Alteration of report with regards to installation of circulating cooling system of spent fuel pool of Unit 1~4 of Fukushima Daiichi Nuclear Power Station (summary)

1. Summary

Figure 1 Main alteration points at Unit 1

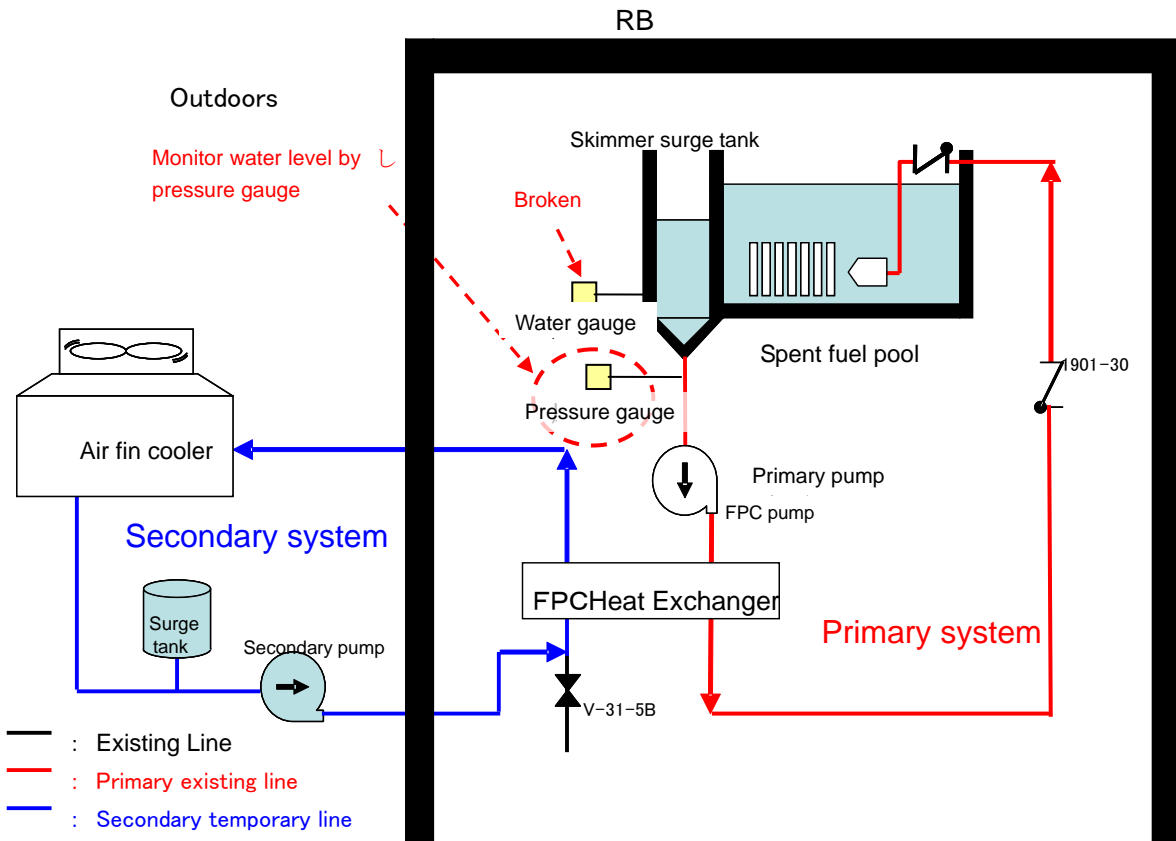
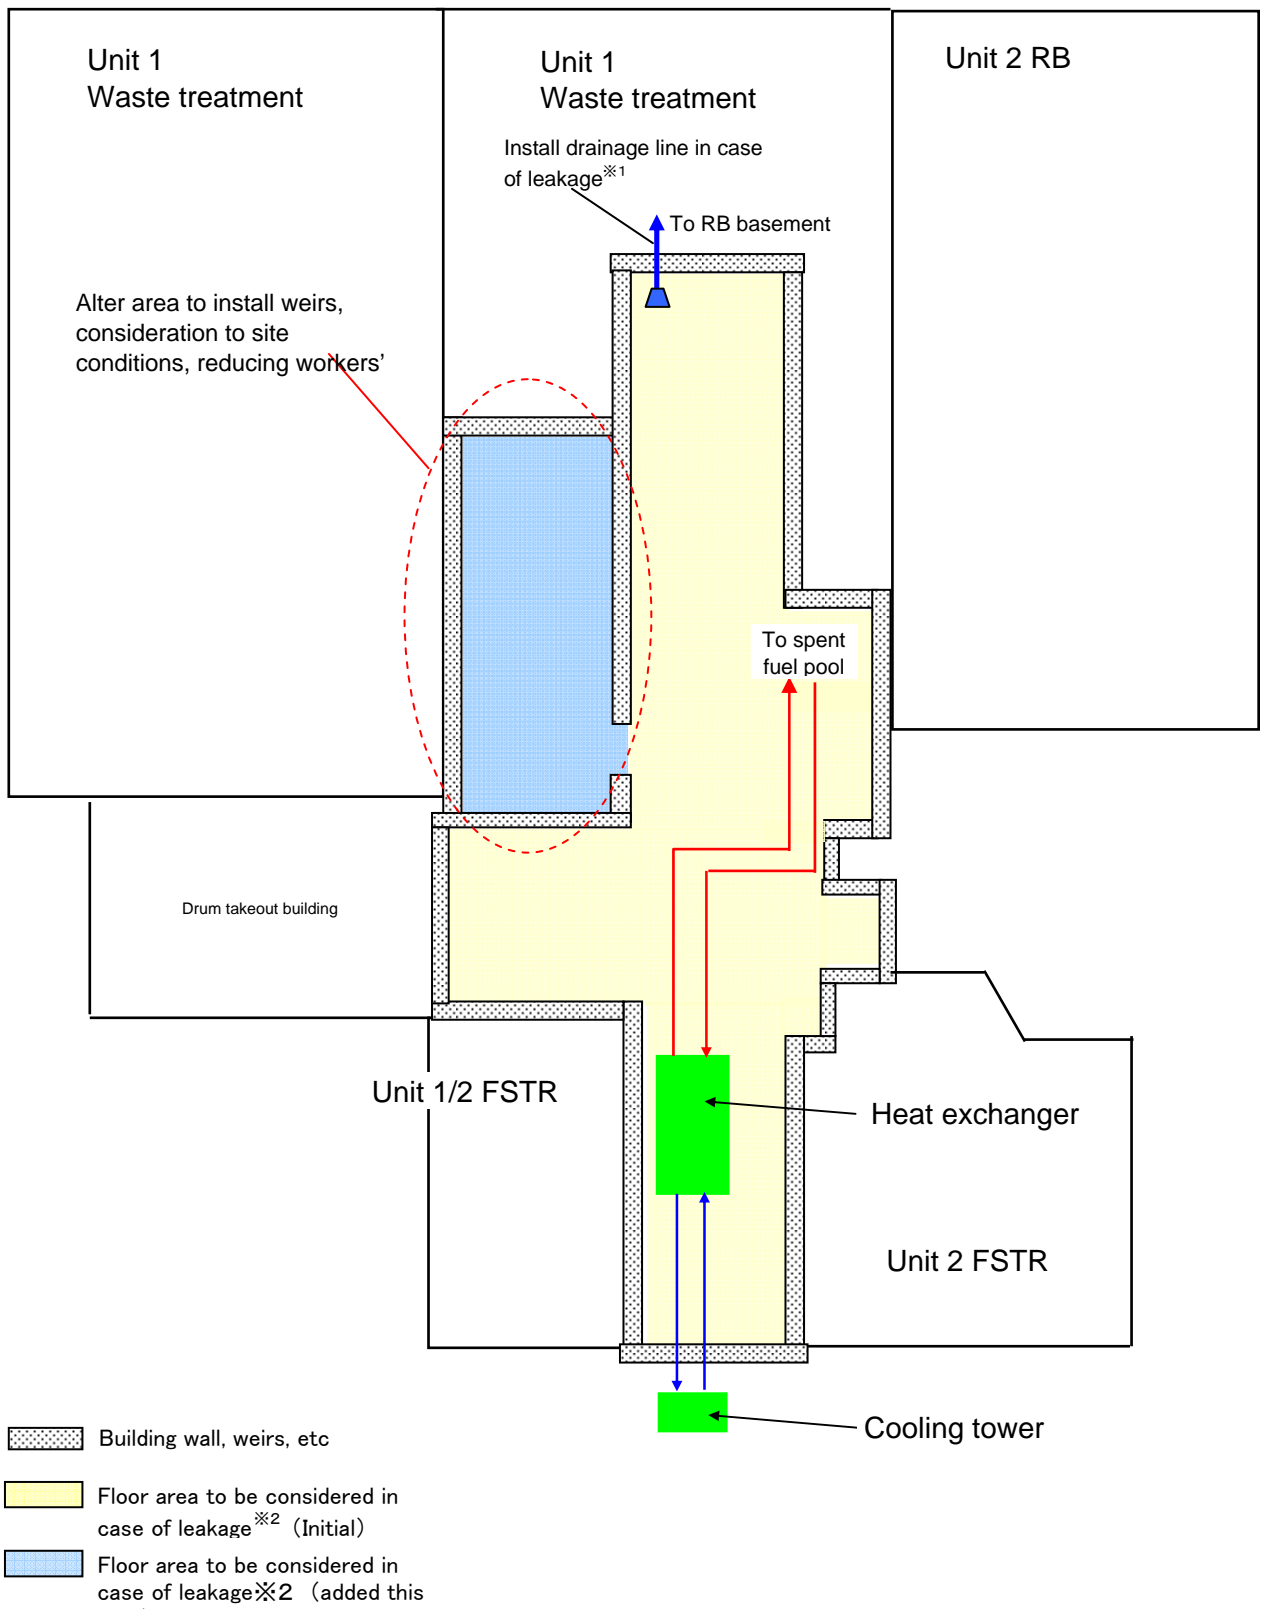
Context of alteration
Unit 1	In order to maintain spent fuel pool water level and manage leakage, we have reported to monitor the water level of skimmer surge tank by existing skimmer surge tank water gauge. However, we will alter this method as the corresponding water gauge is broken. (ref. Figure 1)
Unit 2	We will alter the layout of weirs etc to prevent leakage of contaminated water outside building, as a result of consideration to reducing workers' exposures. We will partly amend the evaluation result of estimated leakage amount, in cases leakage occur. We will add method to treat accumulated water containing radioactive materials within buildings, in cases leakage occur (ref. Figure 2)
Unit 3	We will add method to treat accumulated water containing radioactive materials within buildings, in cases leakage occur
Unit 4	We will alter the area to install weirs, and alter method to drain leakage water, as a result of consideration to site conditions, working environment safety and constructing conditions (ref. Figure 3).

Figure 2 Main alteration points at Unit 2

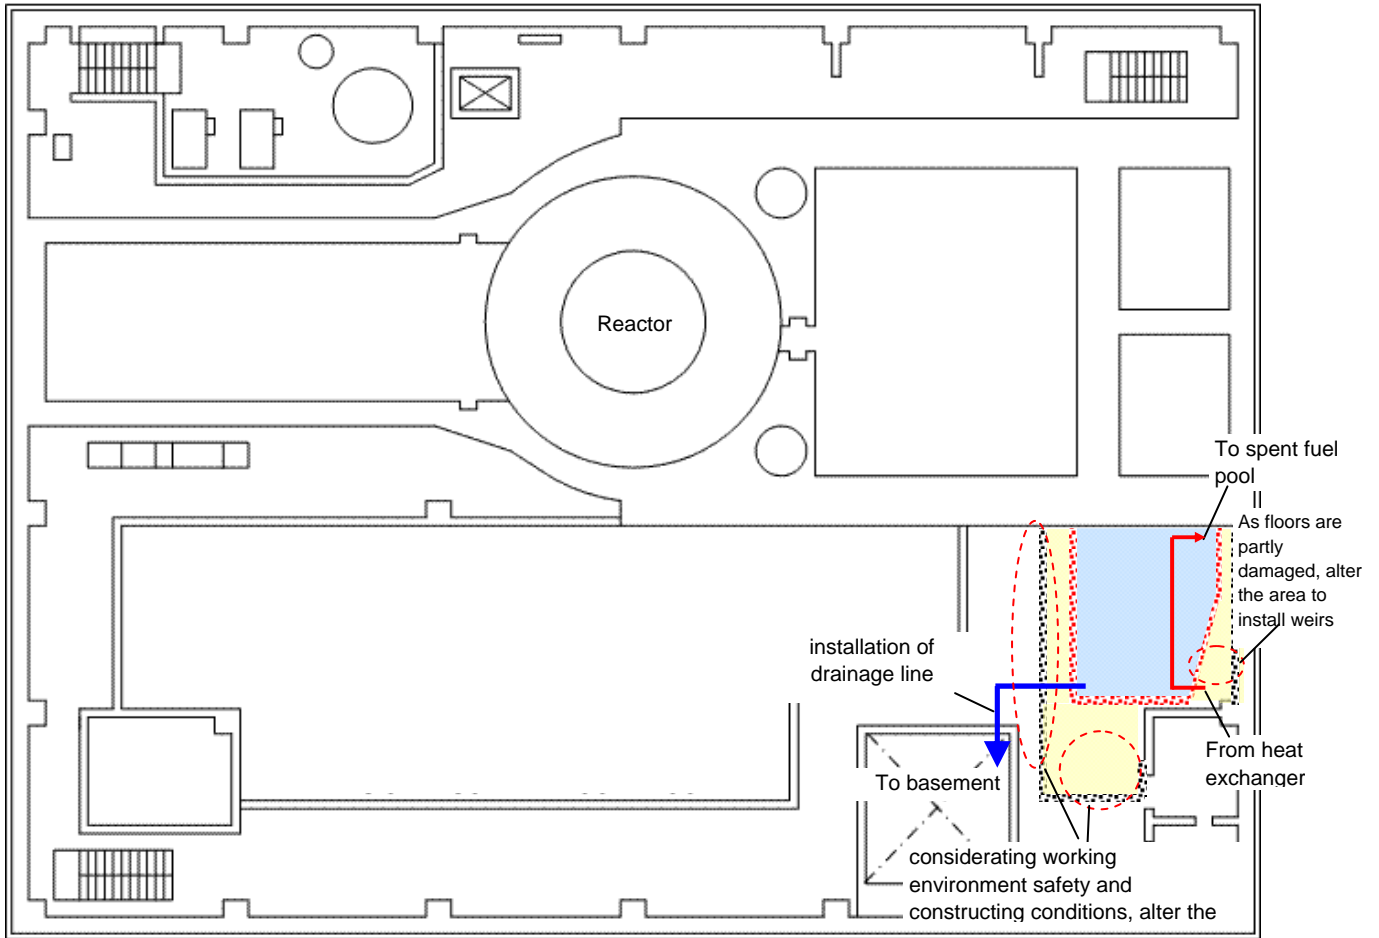
※1: drainage line to be similarly installed at Unit 3

※2: As a result of re-evaluating the estimated leakage amount after adding water of existing system, we have evaluated that measures to prevent leakage outdoors is effective.
